UNITED STATES PATENT AND TRADEMARK OFFICE

APPLICATION NO.	FILING DATE	FIRST NAMED INVENTOR	ATTORNEY DOCKET NO.	CONFIRMATION NO.
09/935,158	08/23/2001	Jang-Kun Song	06192.0203.NPUS00	9225
7590	07/28/2004		EXAMINER	
McGuire Woods LLP 1750 Tysons Boulevard Suite 1800 McLean, VA 22102-4215			RICHARDS, N DREW	
			ART UNIT	PAPER NUMBER
			2815

Office Action Summary	Application No.	Applicant(s)
	09/935,158	SONG, JANG-KUN
	Examiner N. Drew Richards	Art Unit 2815

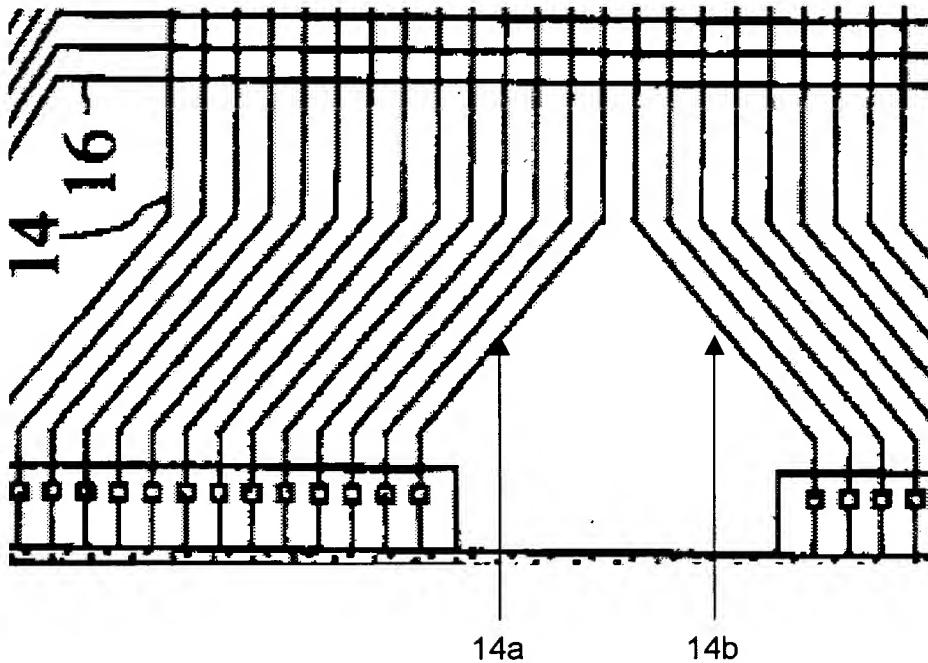
Takizawa et al. disclose a liquid crystal display (LCD) in figures 1-35. Specifically, figure 1 shows:

a plurality of first wires 16 formed on a substrate 10 extending in a first direction; and

a plurality of second wires 14 intersecting the first wires, each second wire 14 having a plurality of bending points wherein equidistance points between two neighboring second wires 14 form a substantially straight line. For clarity, a portion of figure 1 is reproduced below. This portion shows that each second wire 14 has a plurality (first and second) bending points and that two neighboring second wires (labeled 14a and 14b below) have equidistance points that form a straight line.

With regard to claim 14, the plurality of bending points are arranged periodically.
